Robert Crown Kiln Room HVAC

ADDENDUM No. 2

April 7, 2026

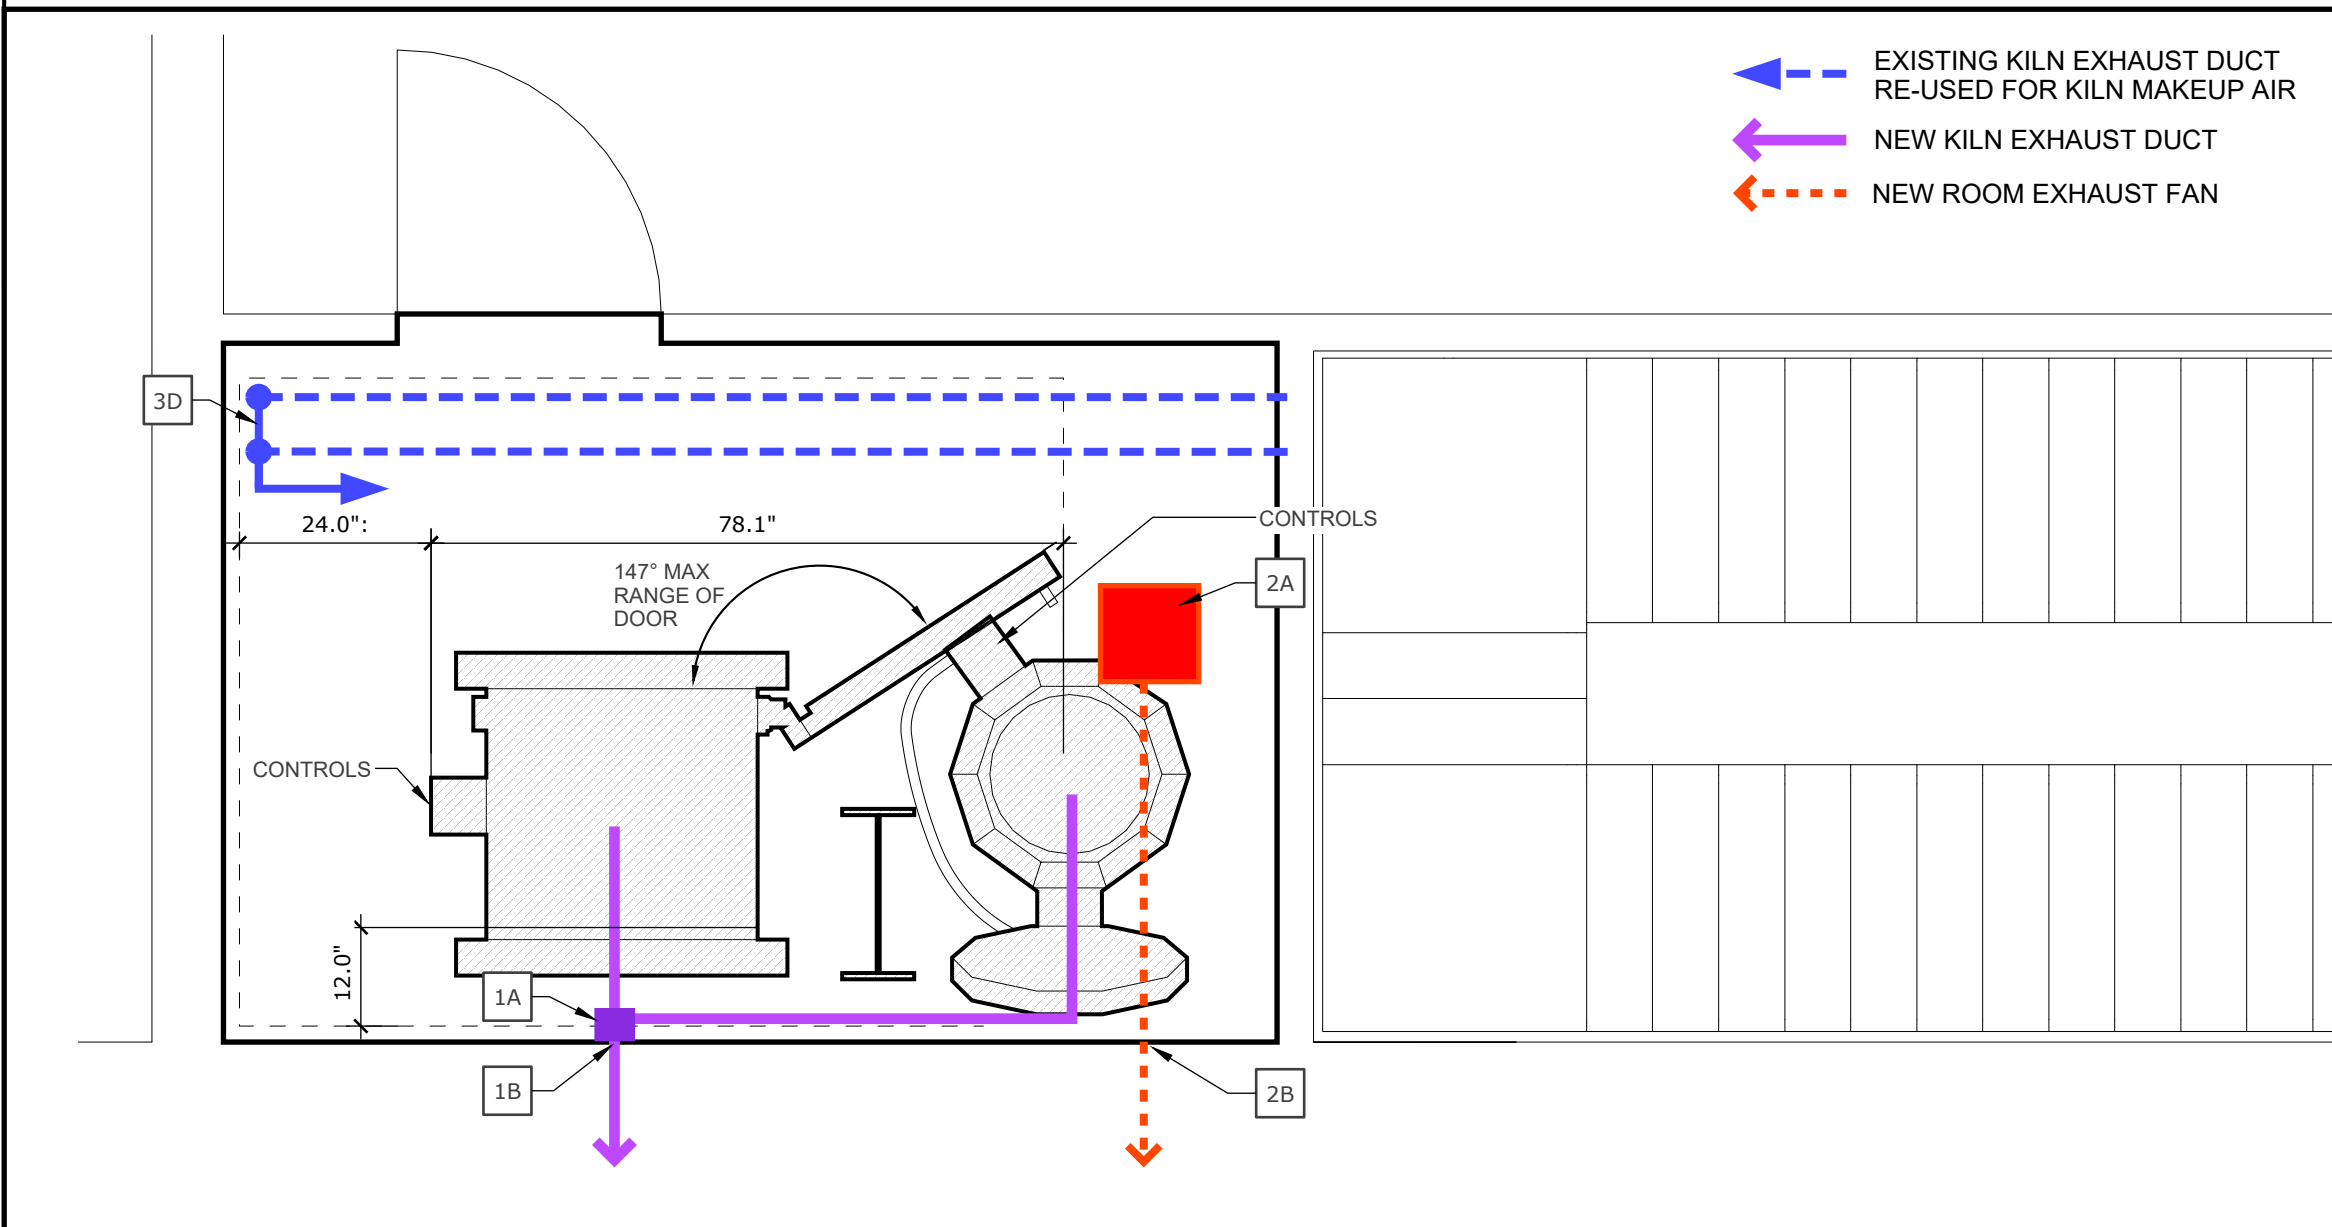
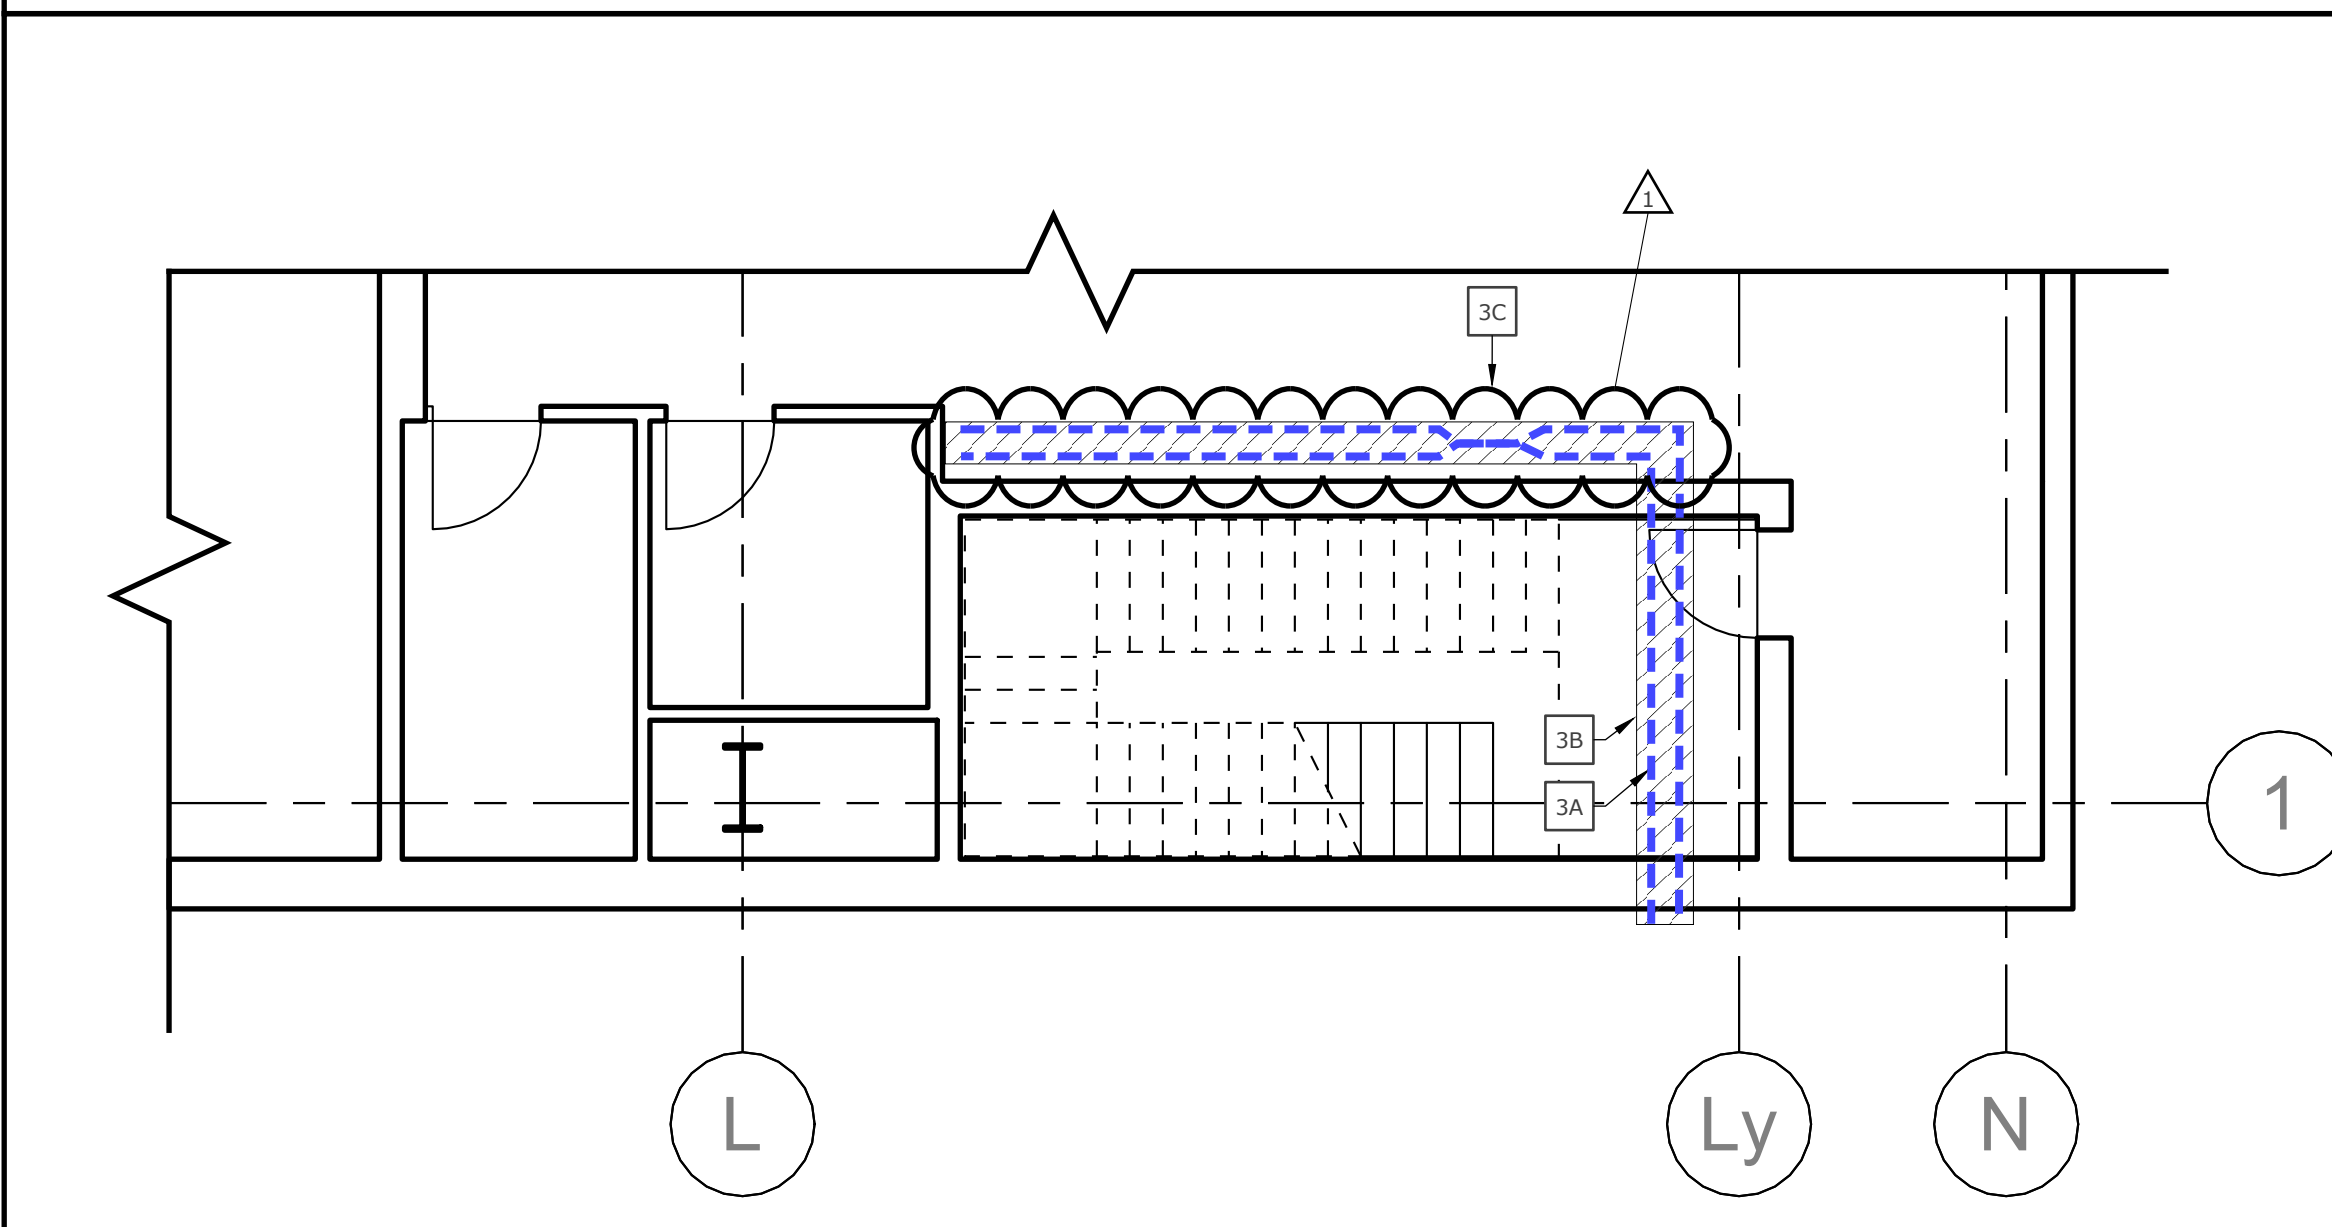
The drawings have been updated to clarify that the existing kiln exhaust ducts should be insulated for their full length.

PHASE 1	
1A	NEW KILN EXHAUST FAN (KEEF-1) DUCTED DIRECTLY THROUGH WEST WALL.
1B	ROUND OUTSIDE AIR LOUVER, 6" ALUMINUM.
2A	NEW GENERAL EXHAUST FAN (GEF-1) SUSPENDED FROM CEILING, DUCTED DIRECTLY THROUGH WEST WALL.
2B	ROUND OUTSIDE AIR LOUVER, 5" ALUMINUM.
3A	EXISTING KILN EXHAUST DUCTS TO REMAIN FOR RE-USE AS MAKEUP AIR.
3B	INSULATE DUCTWORK CONTINUOUSLY FOR THE FULL LENGTH OF THIS RUN.
3C	EXISTING DUCTS COMBINED AND CONNECTED TO NEW FRESH AIR FAN (6" to 4" 2-Way Splitter Duct Connection)
3D	EXISTING DUCTS COMBINED (6" to 4" 2-Way Splitter Duct Connection) INTO SINGLE 6" DUCT EXTENDING TO CEILING, TERMINATING W/ SUPPLY VENT.
